Appl. No. : **10/728,063**
Filed : **December 4, 2003**

AMENDMENTS TO THE DRAWINGS

REMARKS

Figure 2

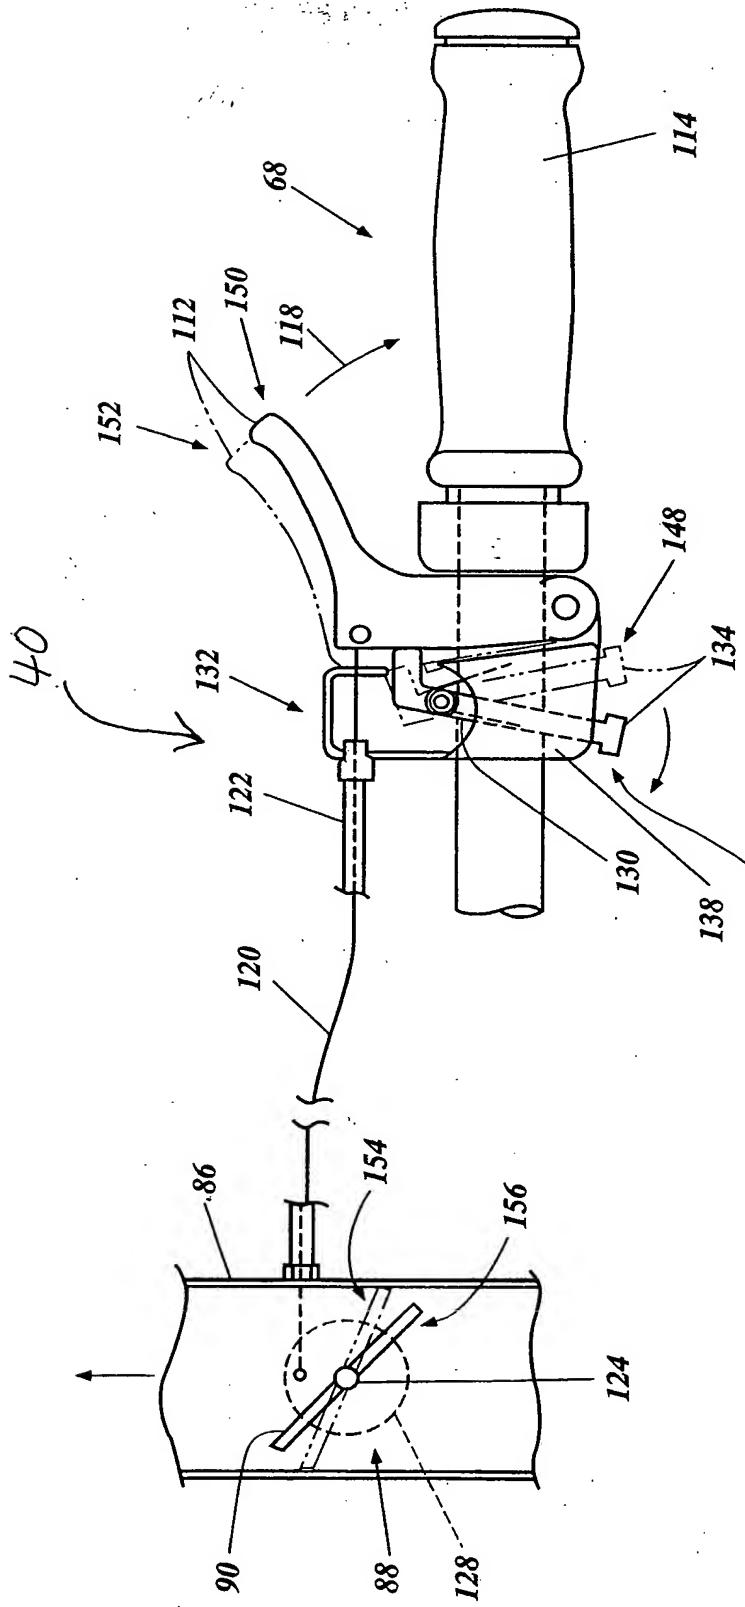
Applicants have amended Figure 2 and added Figure 2b as shown on the attached drawing sheets. These drawing sheets include a "Replacement Sheet" and a marked up version showing the changes to Figure 2 in red ink. Additionally, new Figure 2b is submitted on an additional separate sheet. As fully explained below, Applicants respectfully assert that these drawing changes are fully supported by the originally filed specification and claims, and therefore do not constitute new matter.

The Examiner objected to the drawings under 37 CFR 1.84(p)(5) as not including reference numeral 40 mentioned in the description. Applicants submit herewith an amended drawing sheet in compliance with 37 CFR 1.121(d) including reference numeral 40 (see Figure 2). Accordingly, Applicants respectfully request that the Examiner withdraw this objection.
